**RE: Response to Approval with Modifications  
Investigation Work Plan Solid Waste Management Unit 1  
Marathon Petroleum Company LP, Gallup Refinery  
(dba Western Refining Southwest, Inc.)  
EPA ID# NMD000333211**

**RESPONSE TO APPROVAL WITH MODIFICATIONS SWMU-1 SOIL  
SAMPLING INVESTIGATION WORK PLAN**

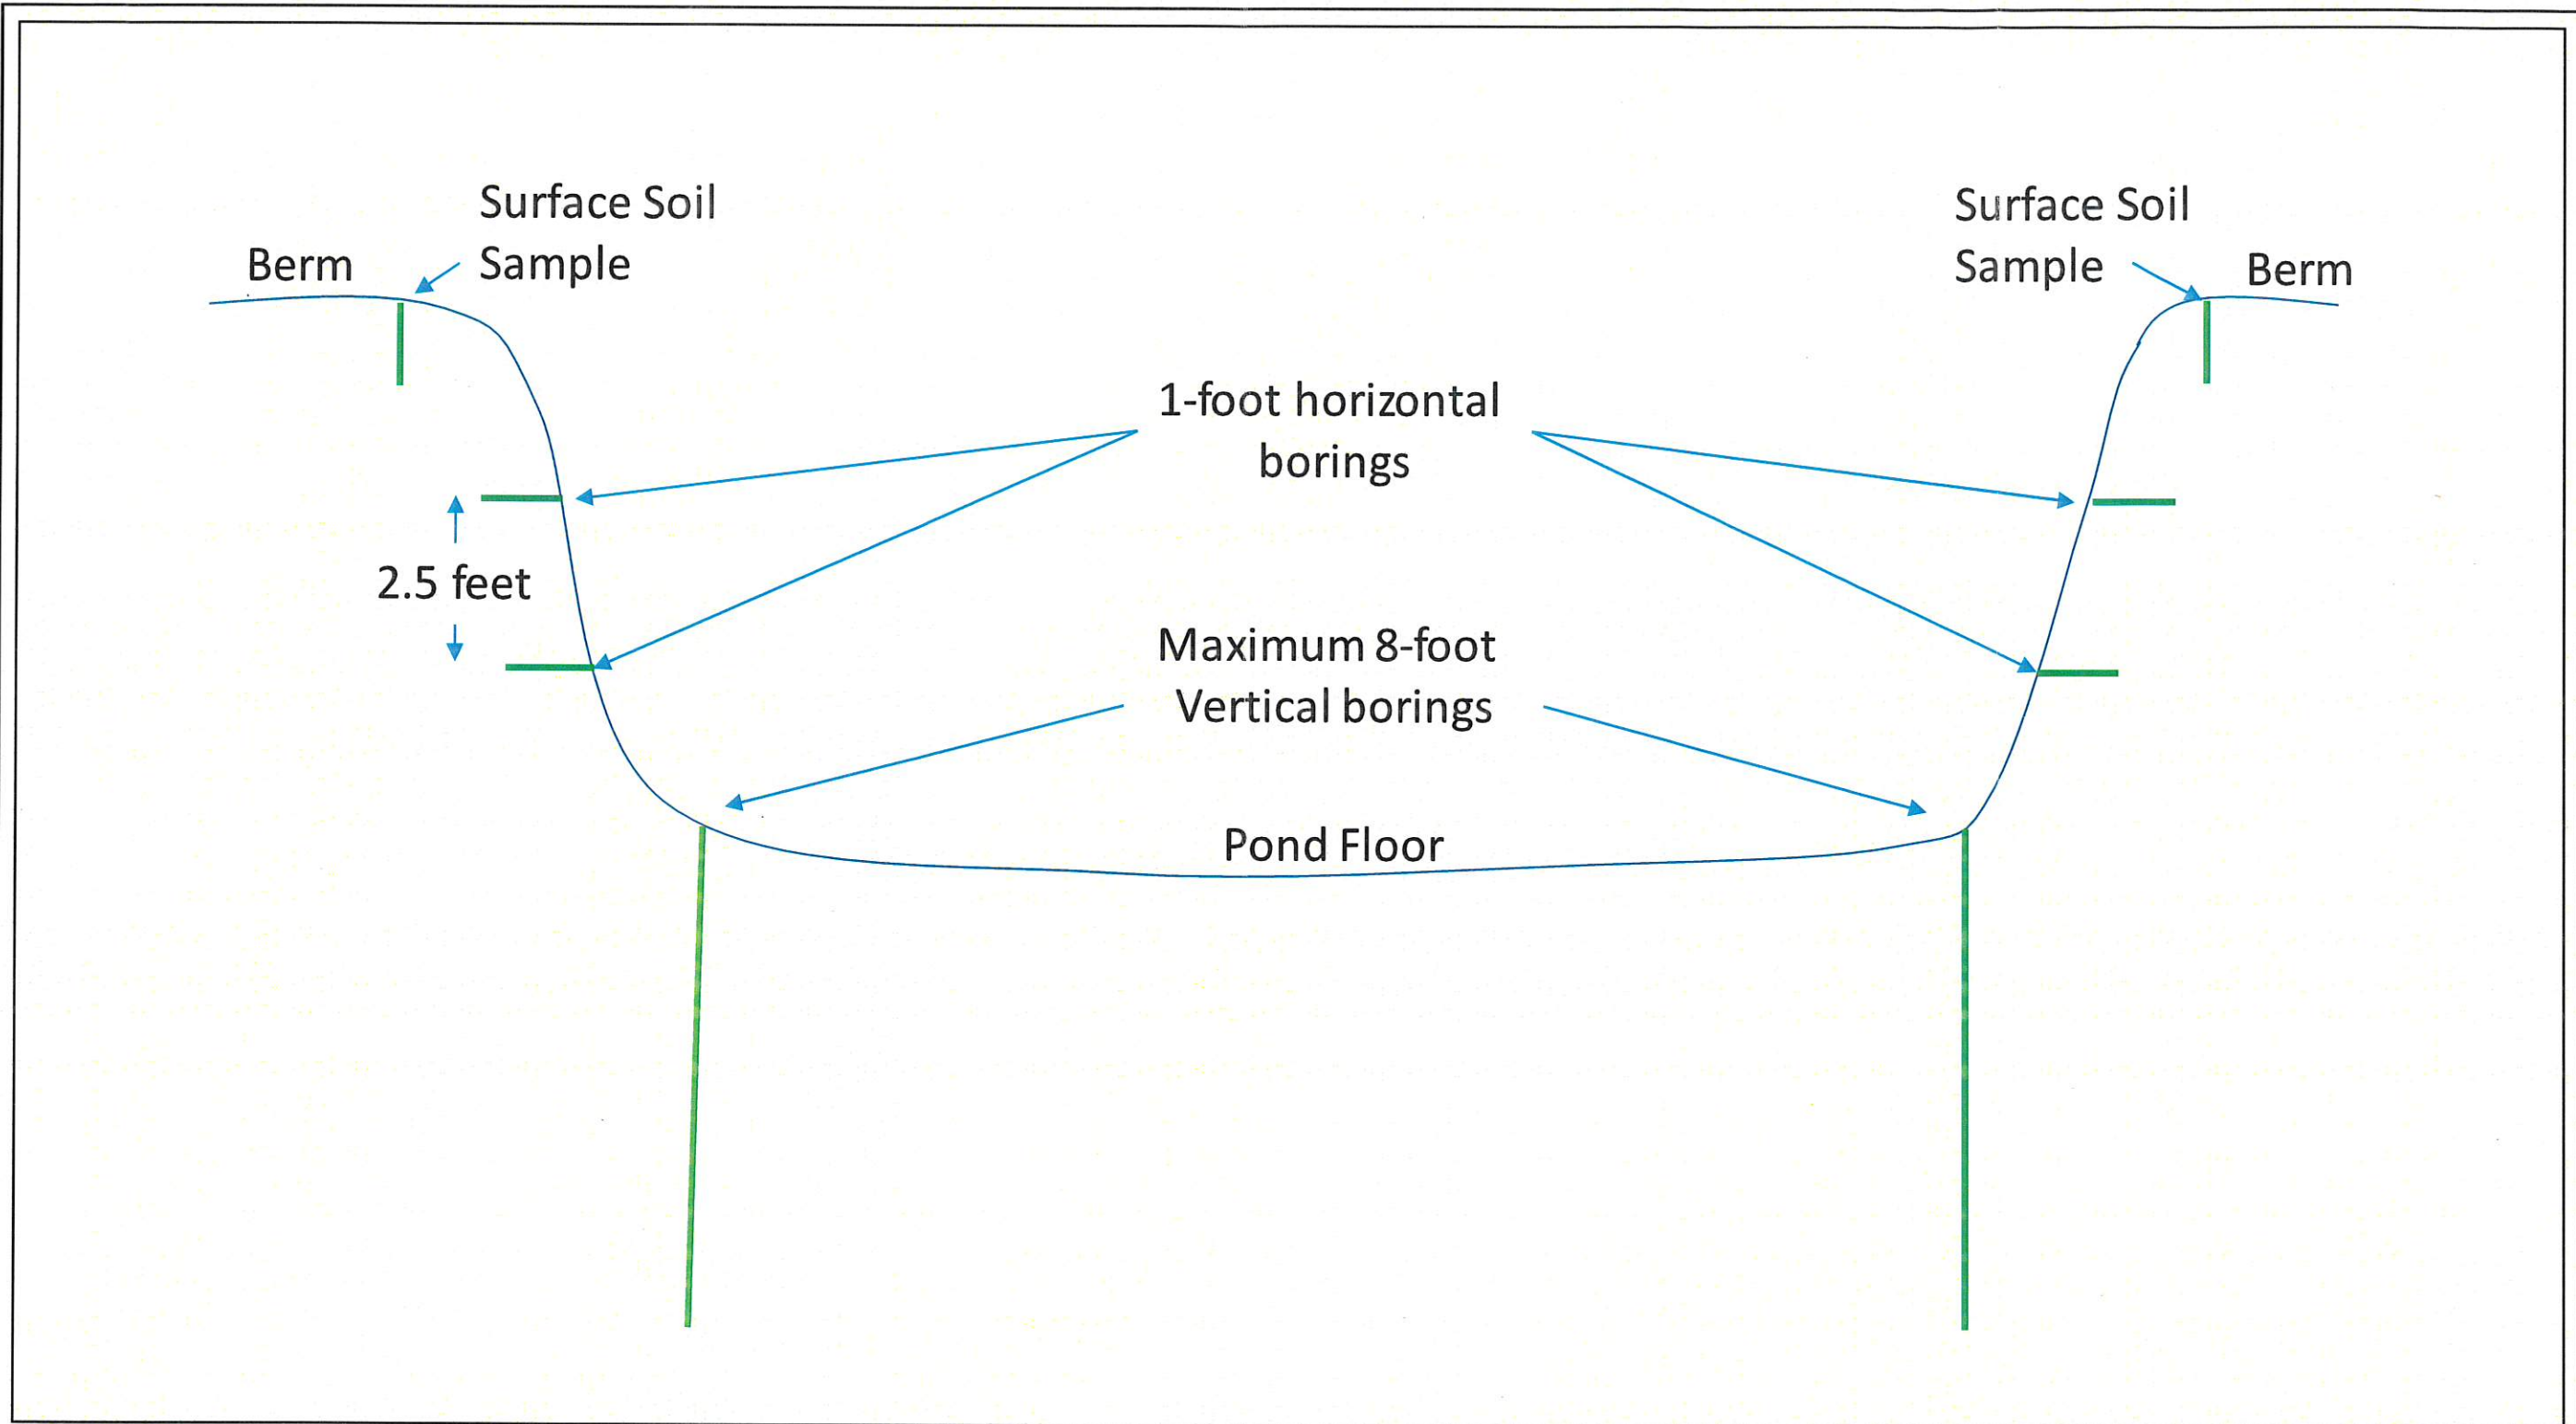
Under the heading "Investigation Methods", the Permittee states, "[s]oil samples will be collected by hand-augering within SWMU 1 and along the perimeter sidewalls (Figure 3). Discrete sediment samples will be collected at 2.5-ft intervals from the surface until visual and/or instrumental contamination is no longer evident, or until a maximum depth of approximately 8 feet is reached." The Permittee does not specify if the berm sidewall samples will be collected using a hand auger or with a different tool and does not specify to what depth/horizontal position the berm sidewall samples will be collected. Provide this information in a response letter.

SWMU 1 sidewall soil samples along the berm will be collected using a hand auger. The first sample will be collected from the top surface of the berm and advanced 1-foot vertically into the berm. The next sample will be collected approximately 2.5-foot below the top of the berm (Figure 3a) and advanced 1 foot horizontally into the berm side wall. Additional samples will be collected approximately at 2.5-foot intervals until the toe of the berm is reached. Samples at the toe of the

berm will be collected vertically from the surface, at 2.5-foot intervals to an 8-foot maximum depth or until visual staining and/or no instrumental response is detected (Figure 3a). A sample will also be collected from any saturated intervals.
